ARIEL CORPORATION

Product Release Announcement

Ariel JGM/P/N/Q Two Throw Frame Improvements

Vibration Monitoring:

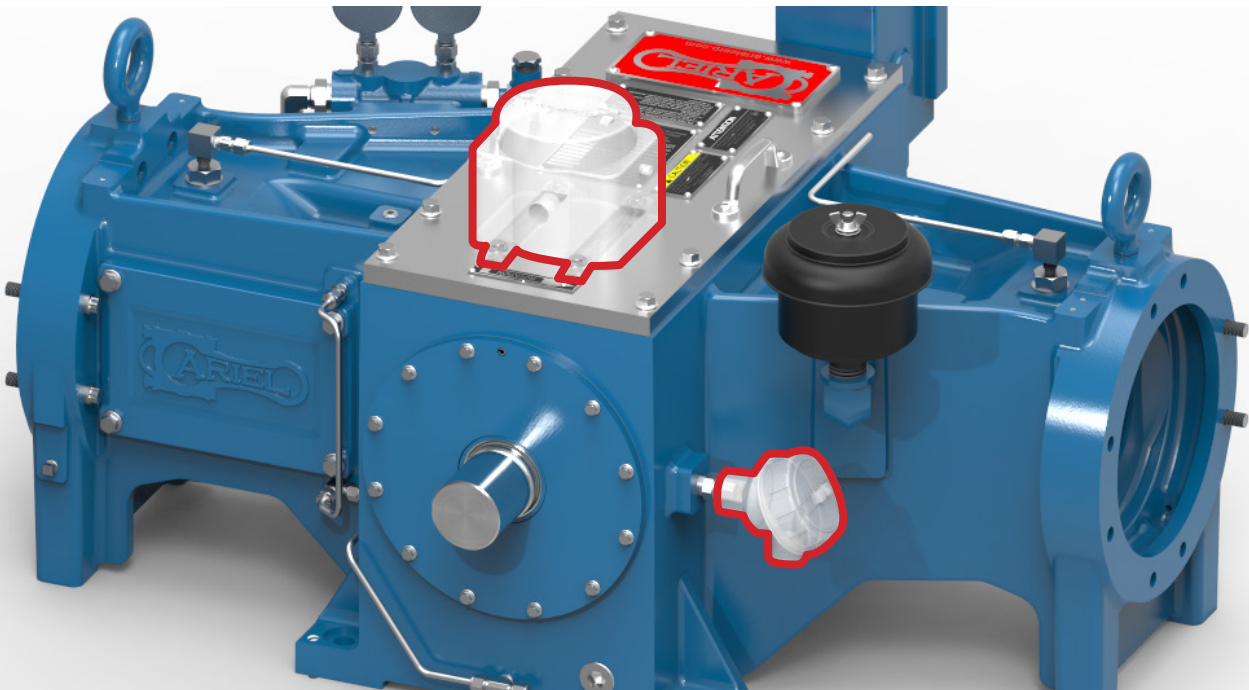
- Top cover predrilled for several common vibration switches
- Drive end boss for accelerometer

Revised Frame Ribs:

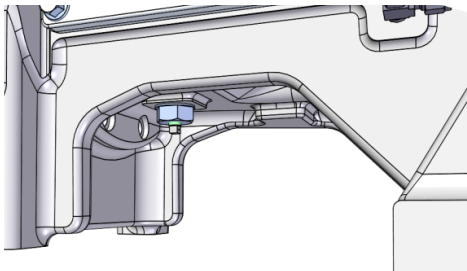
- Allow better access for maintenance and packaging
- Reduces allowable immersion heater length
